M	VP Vari	ance Req	uest	Form	Varia	ance Request			
N NAO.	provol D	oguaatad	No.: by Contractor:	F-9	10					
y Mou	ntain Valley			5/15/201	18					
•	Valley Date S									
			FERC .	Approv		ence No.:	ved by FERC:			
		Variance								
Requested By:	Jonath	nan Zwierzyı	nski		Spread:	F	Type:	WS		
Deguest Branared By *:	4.4.	NI I				Varian	ce Sequence			
Request Prepared By *: Megan Neylon Number: 009 The FERC compliance monitor should be alerted and given a copy of the draft variance for review prior to submittal.										
The FERC compliance monitor should be alerted and given a copy of the draft variance for review prior to submittal. Location (Use either Station or Milepost)										
Station:	N/A	To:		1	· lilepost:		To:	N/A		
Station.	IV/A	Ancillary	N/A	Į iv	illepost.	IVA	10.	IV/A		
Alignment	Sheet Number:				т	ract No.:	WV-RA-6	132 , WV-RA-6 ⁻	131	
			Developed;			r Agency				
Current Land Use/ Ve Nearby Features (Water bo			Pasture/Hay	od	Juri	sdiction:		N/A

Mountain Valley Pipeline Project Variance F-9 June 8, 2018

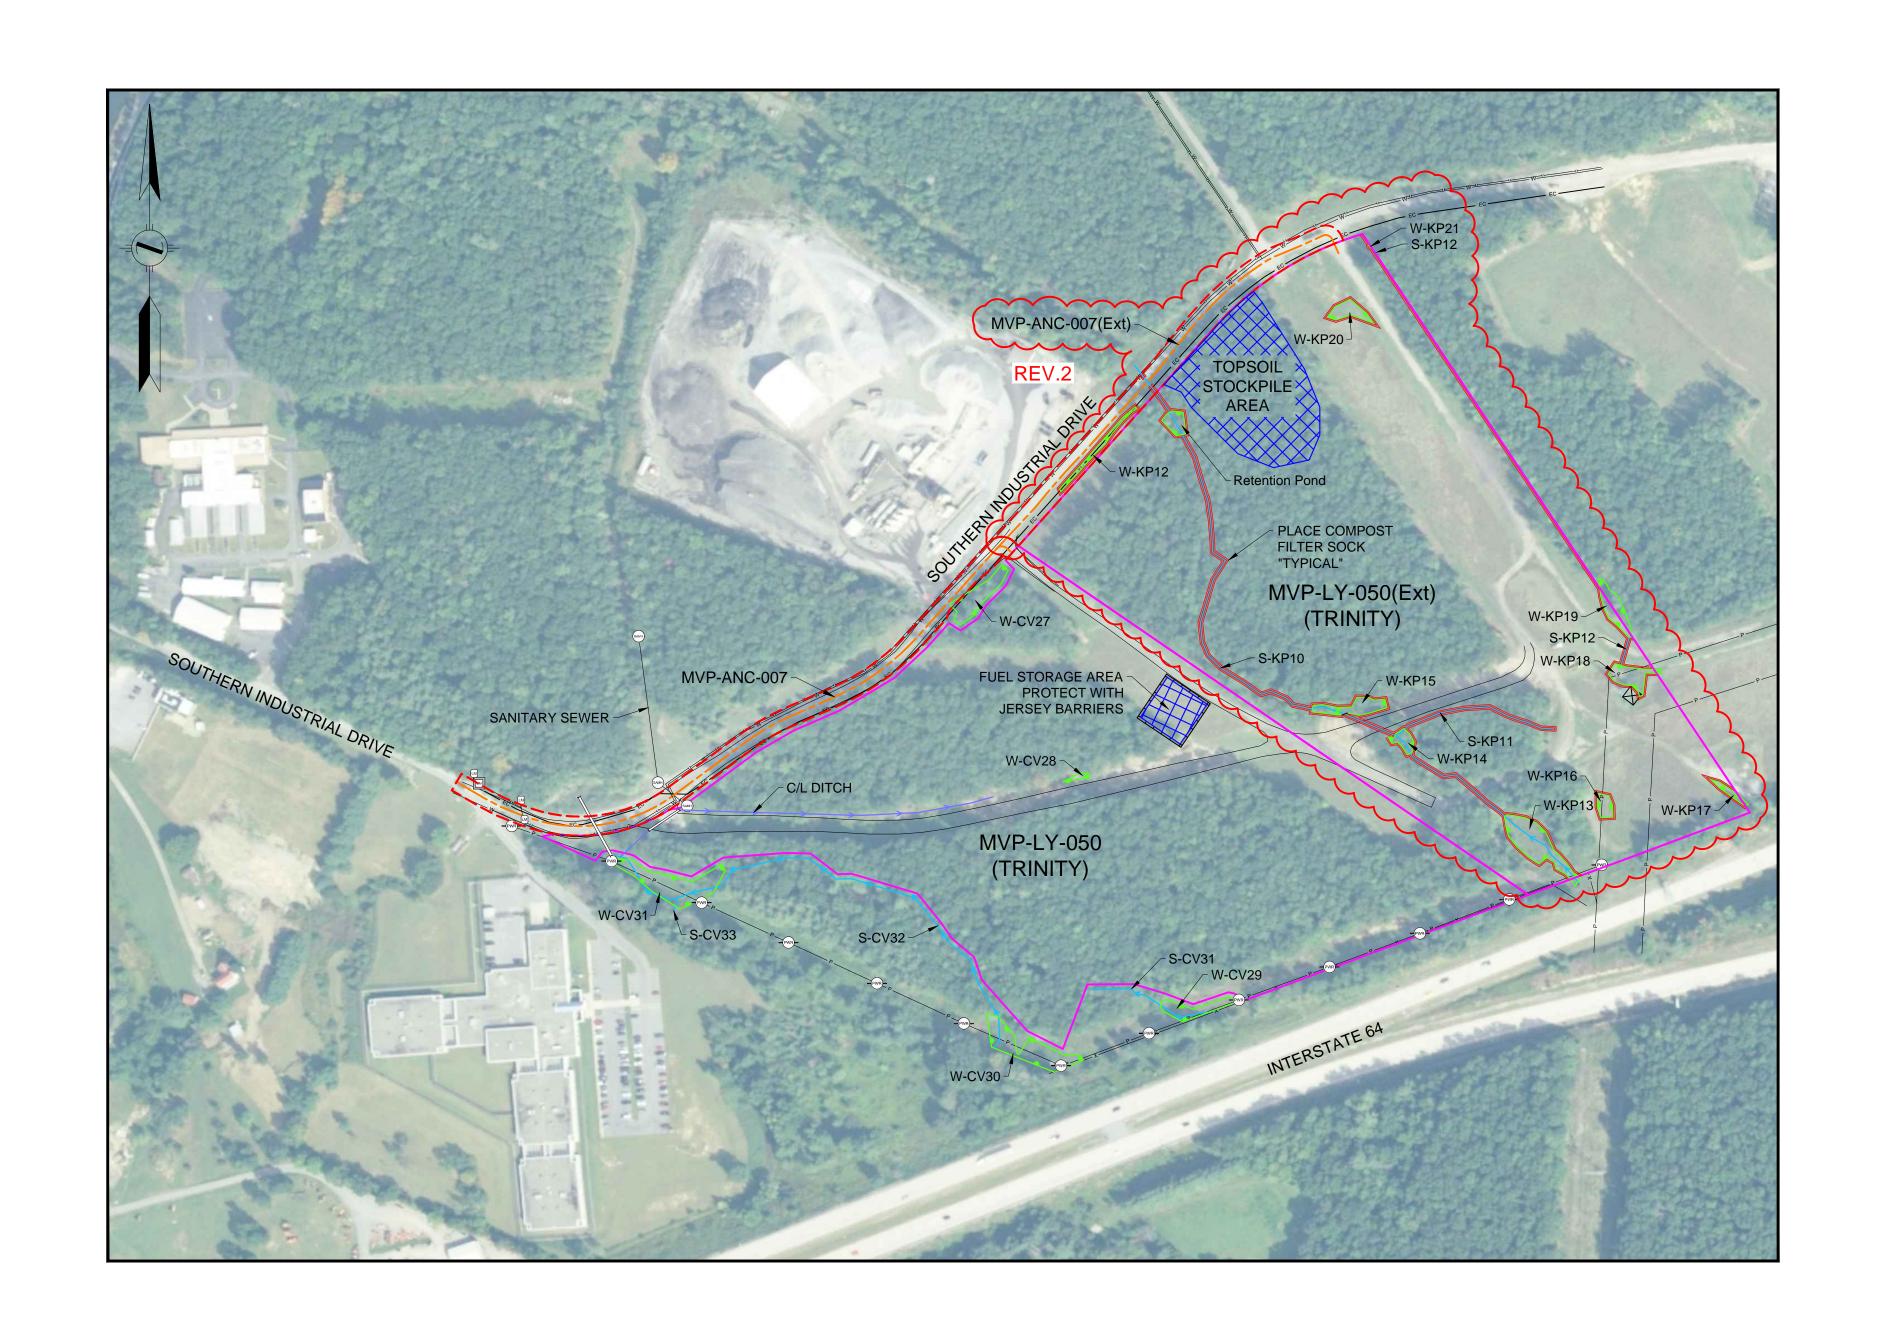
This variance adds laydown yard MVP-LY-050 (Ext) and associated temporary access road MVP-ANC-007 (Ext). Laydown yard MVP-LY-50 (Ext) is necessary for construction staging. This variance adds 23.81 acres to the LOD. No rare, threatened or endangered species or cultural										
resources were found during w have been delineated during su										
KP11 & S-KP12 have been del										
graded, topsoil will be segregat										
remain or will be removed by the No fuel storage will take place of		completion	or construction.	ropso	ii storage v	wiii take pia	ace on the north	an eage of the	site	
List Attachments:	Attachment 1 - Al	ianment Sha	act: Attachment	2 - Par	e Threat	aned and				
LIST ATTACHMENTS:		-	ort; Attachment							
			ment 4 - Cultura							
	Landowner Exhib		DO NOT REI RIV DO NOT F							
			nce Request Ma							
Variance Justification:										
Necessary for construction stage				-		er approve	d Project plans,	BMPs will be in	stalled

LEGI	REFERENCE DRAWINGS			REVISIONS			
ANCILLARY SITE PERMANENT ACCESS ROAD TEMPORARY ACCESS ROAD PROPOSED H600 PIPELINE PROPOSED PERMANENT EASEMENT TEMPORARY WORK SPACE ADDITIONAL TEMPORARY WORK SPACE OF GATE - GATE POST CULVERT PIPELINE MARKER POWER/TELEPHONE POLE DEM ELEC/GAS/WTR METER FIRE HYDRANT & VALVE DEM DEM PEDESTAL - UTILITY	SAFETY FENCE COMPOST FILTER SOCK PIPELINE OHP LINE ROAD RIGHT-OF-WAY LINE FENCE BUILDING WETLAND STREAM WELL - GAS/OIL/WATER/MONITORING PROJECTION: UTM ZONE 17 HORIZONTAL DATUM: NAD 83 US SURVEY FEET VERTICAL DATUM: NAVD88	DRAWING NUMBER	TITLE	0 1 2 3	DRF 03-22-18 DRF 06-12-18 DRF 06-25-18	DESCRIPTION ISSUED FOR VARIANCE RE-ISSUED FOR VARIANCE - ADDED DITCH AND FUEL STORAGE AREA ISSUED FOR ADDITIONAL VARIANCE - ADDED EXTENSION MVP-LY-050(Ext) AND MVP-ANC-007(Ext) ADDED TOPSOIL STOCKPILE AREA ADDED COMPOST FILTER SOCK
